Eng/Ops Bulletin

ECN 1416

March 9, 2015

This ECN is for changing PD box location from cab console OR behind the driver seat to a new standard location in the #2 compartment.

See supplemental drawings & pictures for new PD box location and close out design.

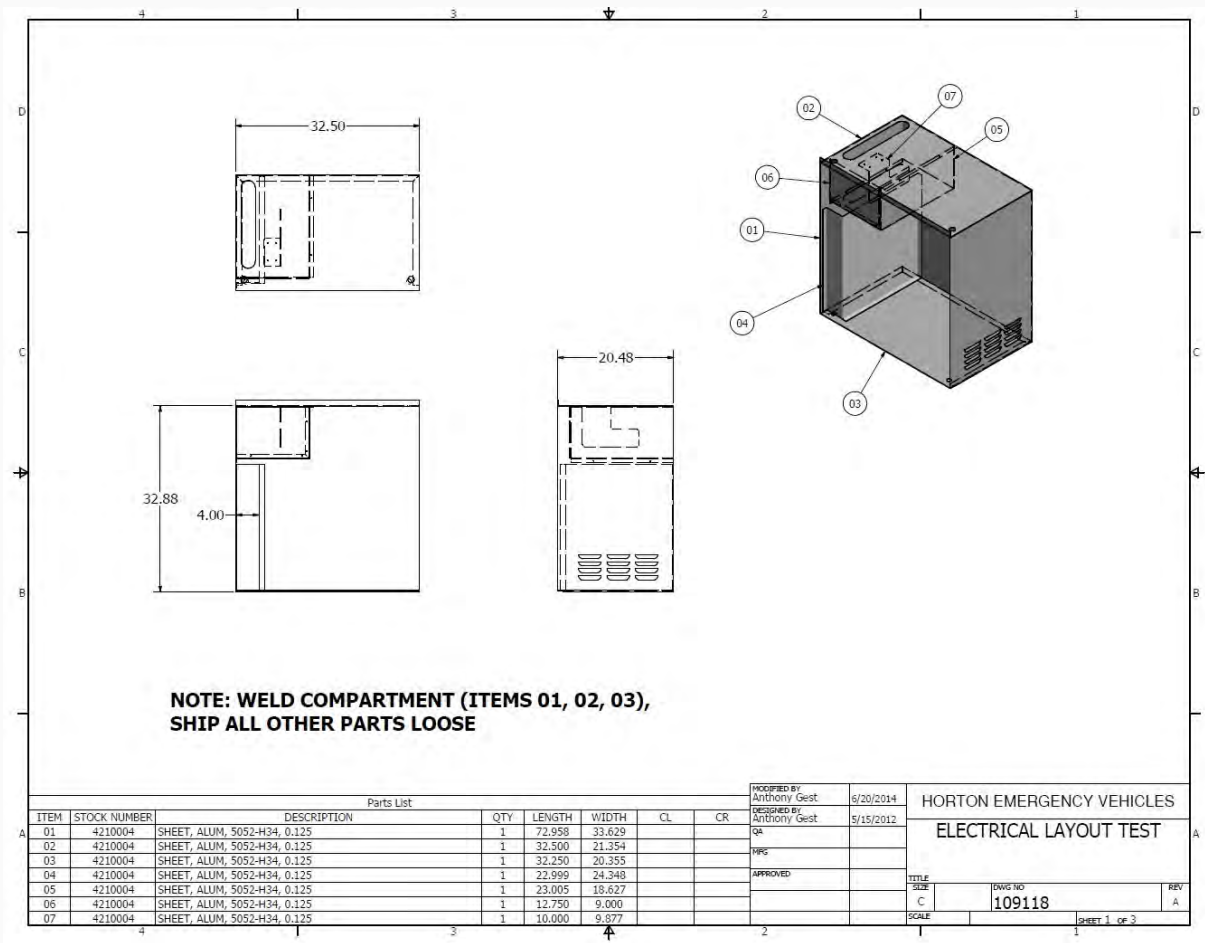
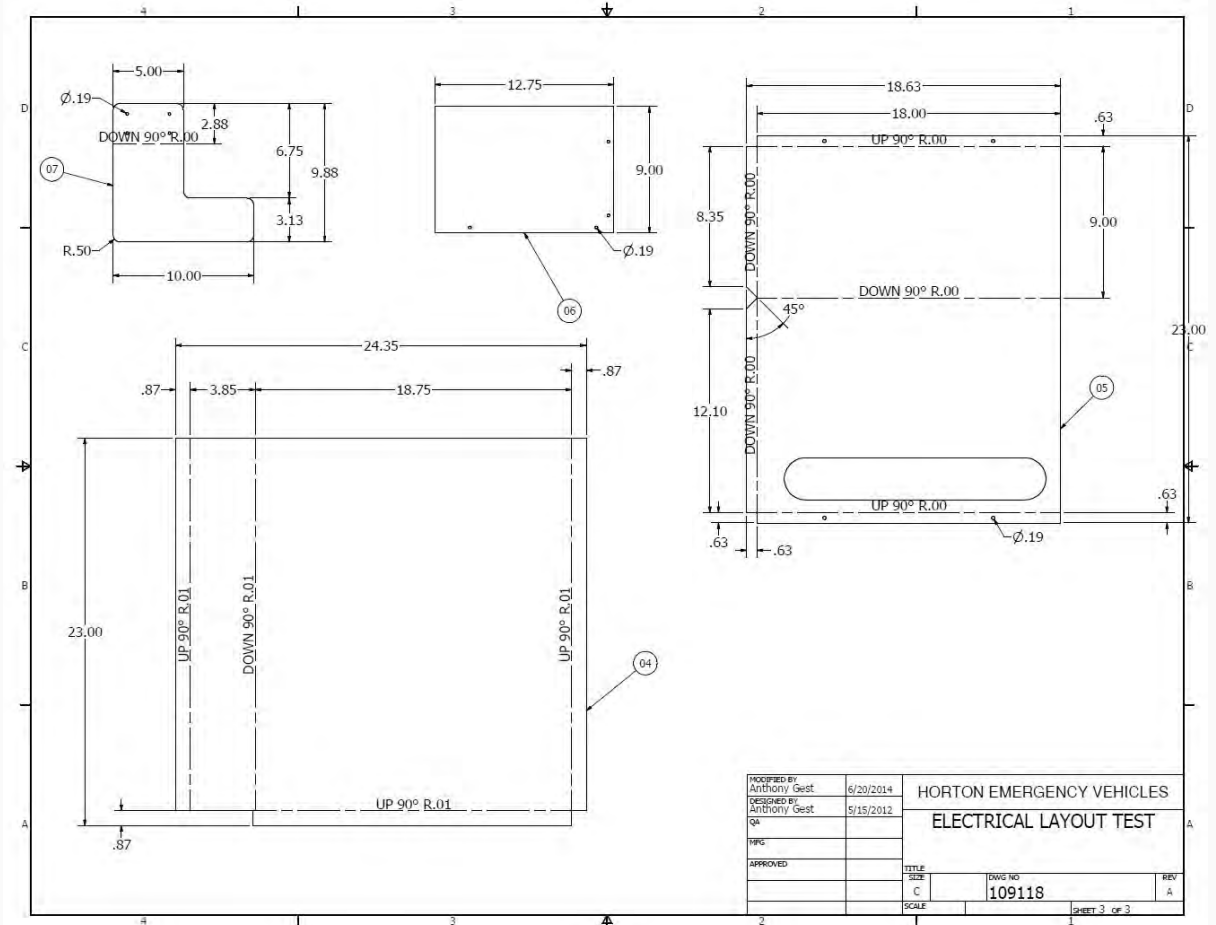
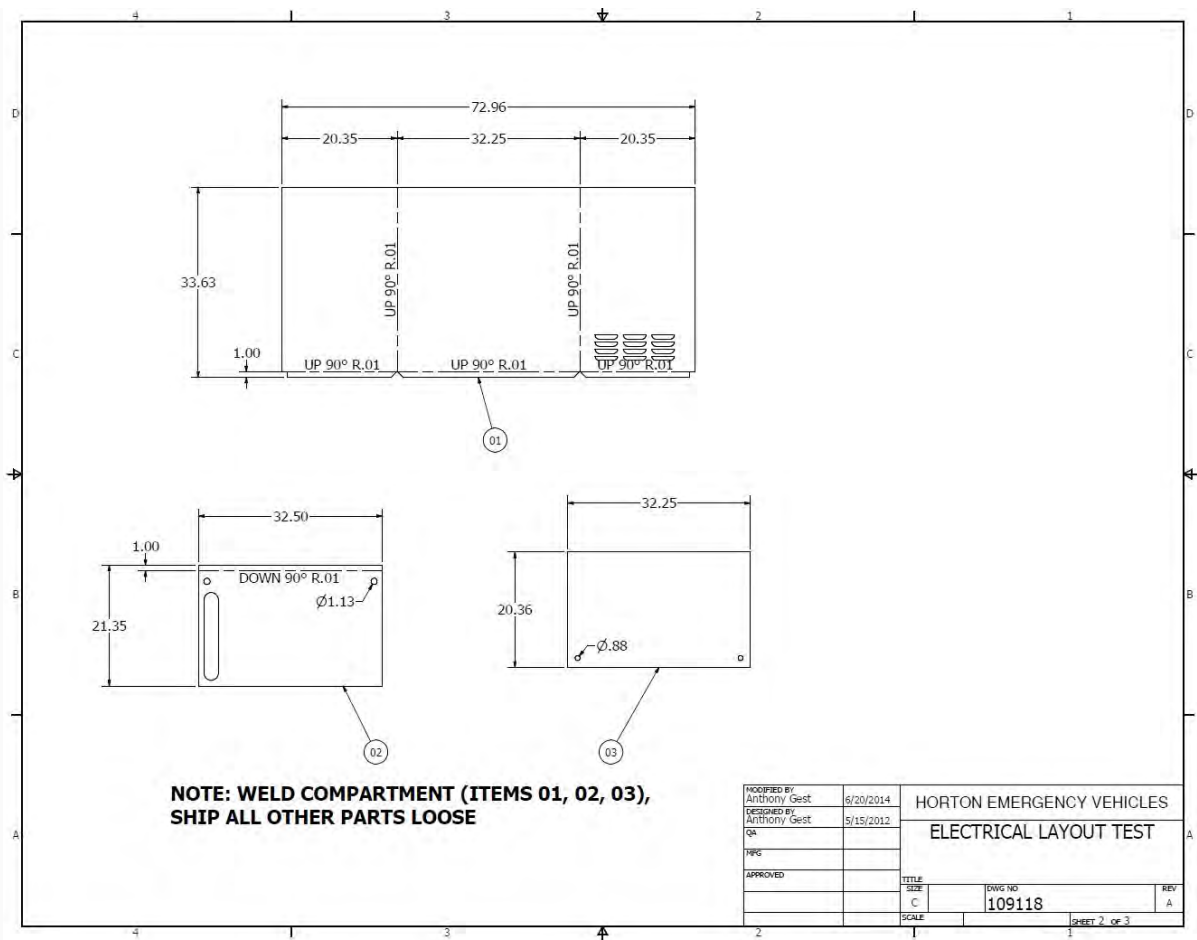
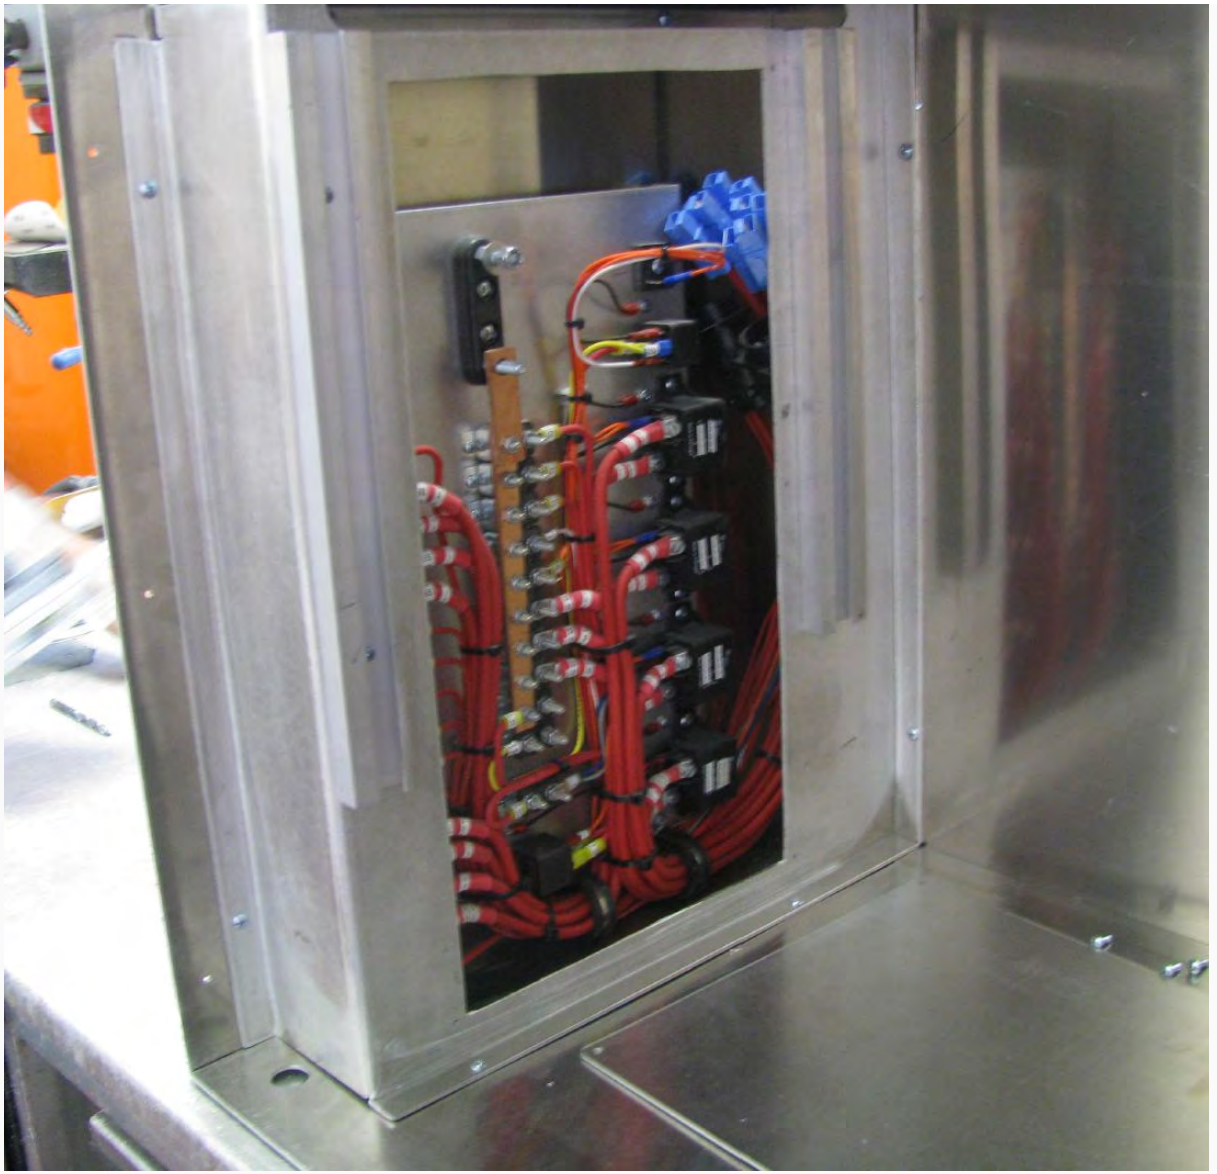
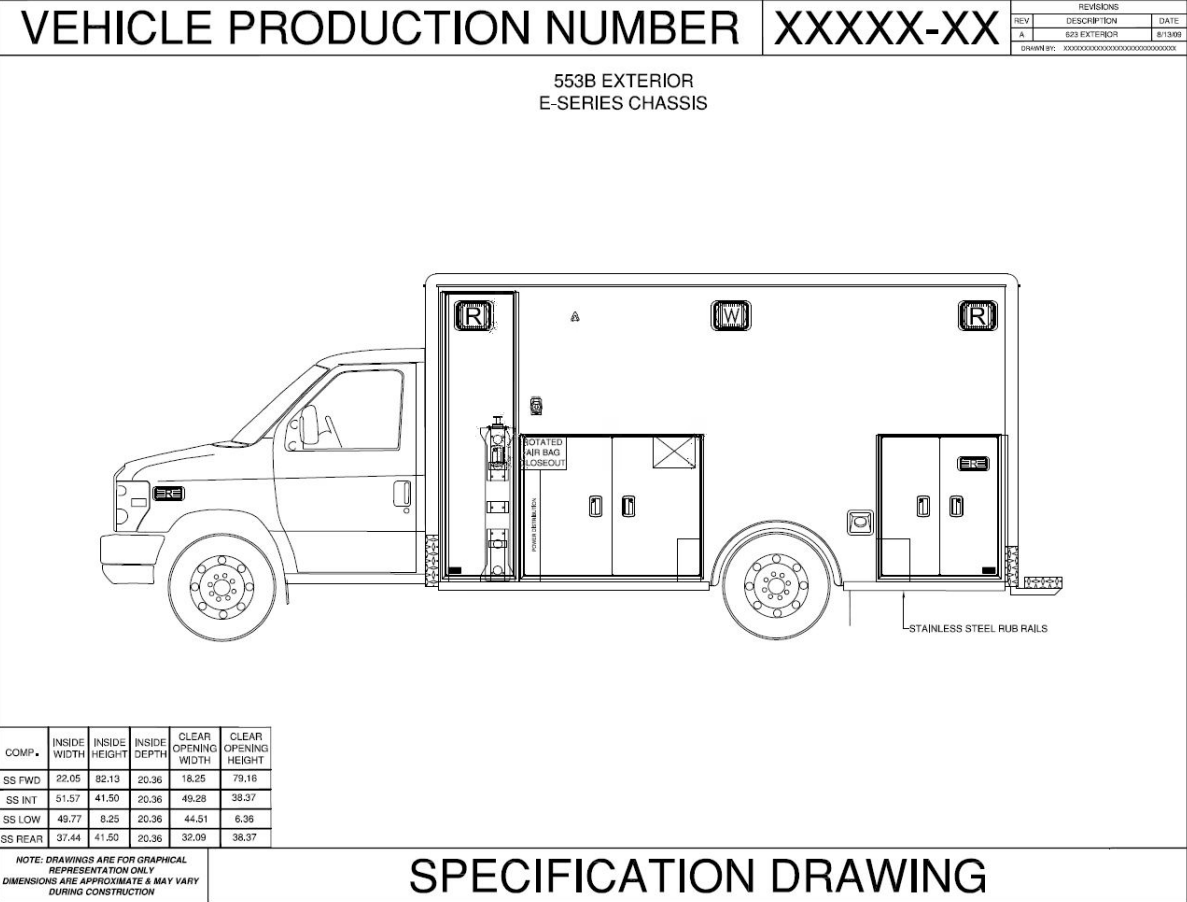
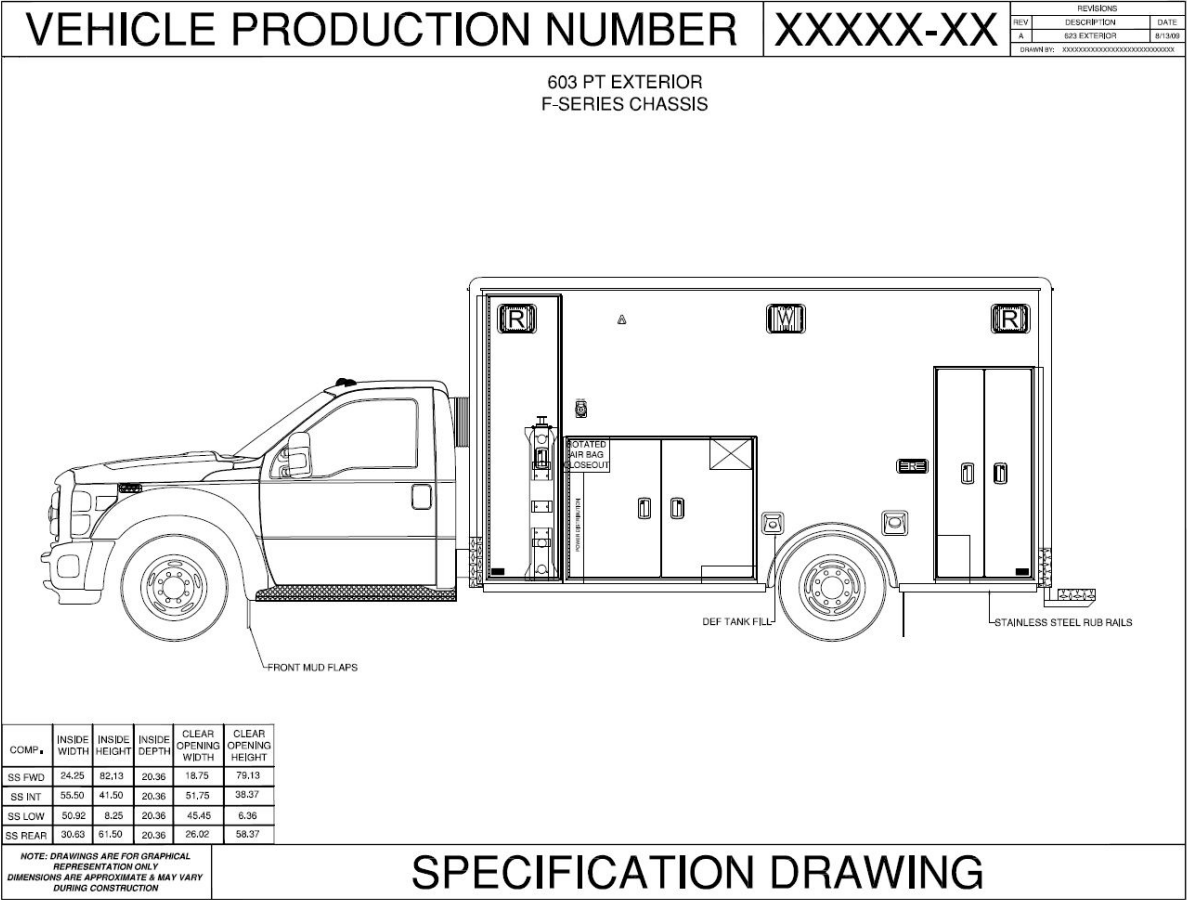
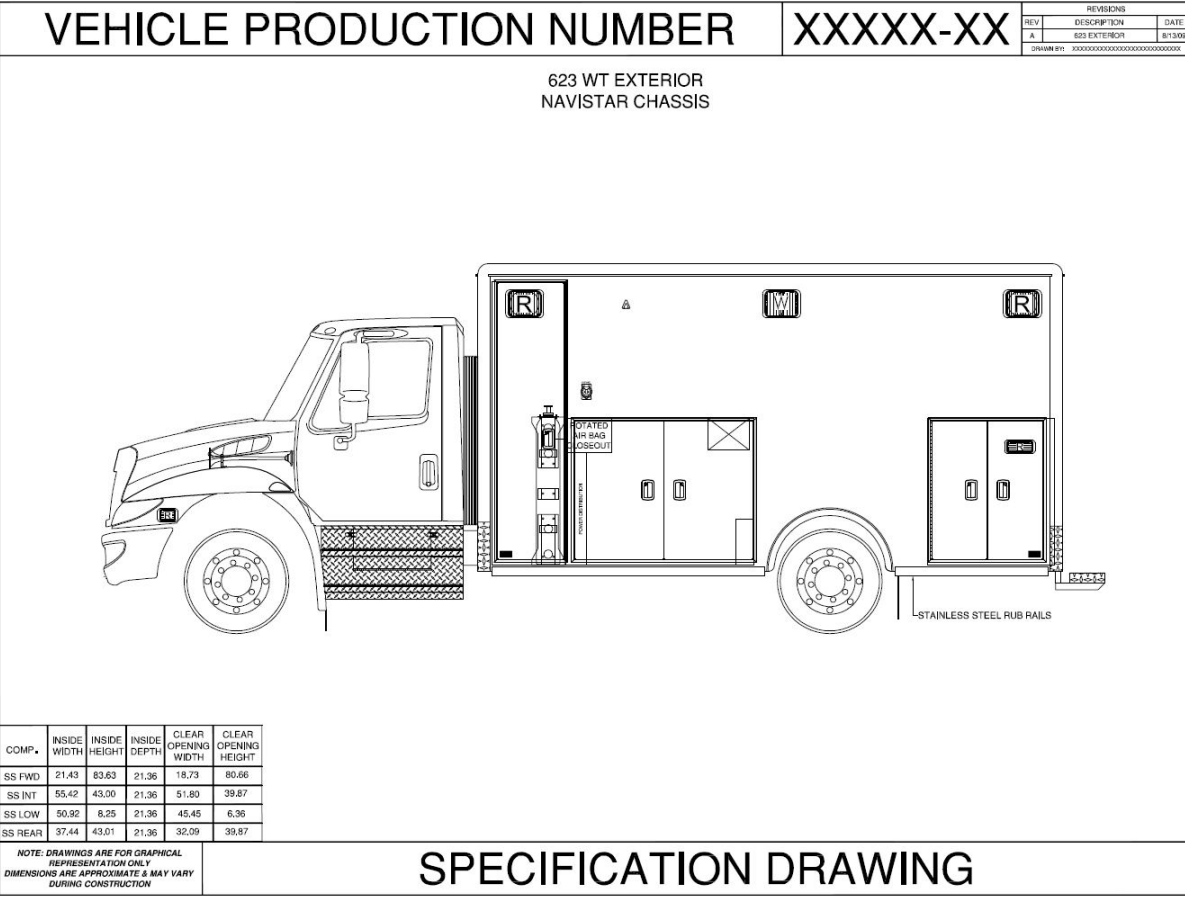
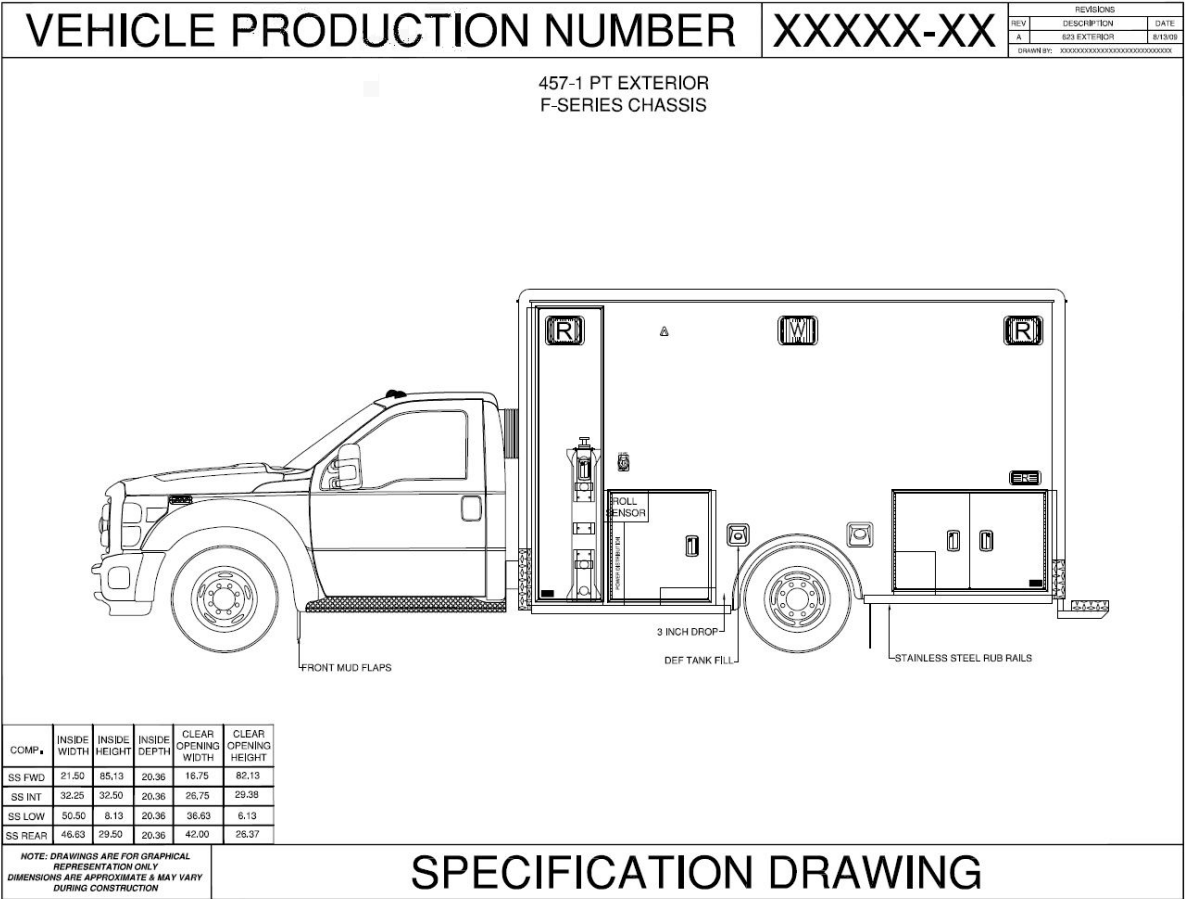
The new location will be on the left side of the #2 compartment under the HOPS close out. With this option the PD box will fit behind a close out with access plate on right side. This design will utilize the rotated HOPS close out option.

Do not locate electrical equipment or any other items that would block access to the PD box. The new PD box close out will be 6" wide and full depth of the compartment. The new location will free space in the cab console and reduce wire box size located behind the driver seat. The new standard location should simplify the PD box design and the install process.
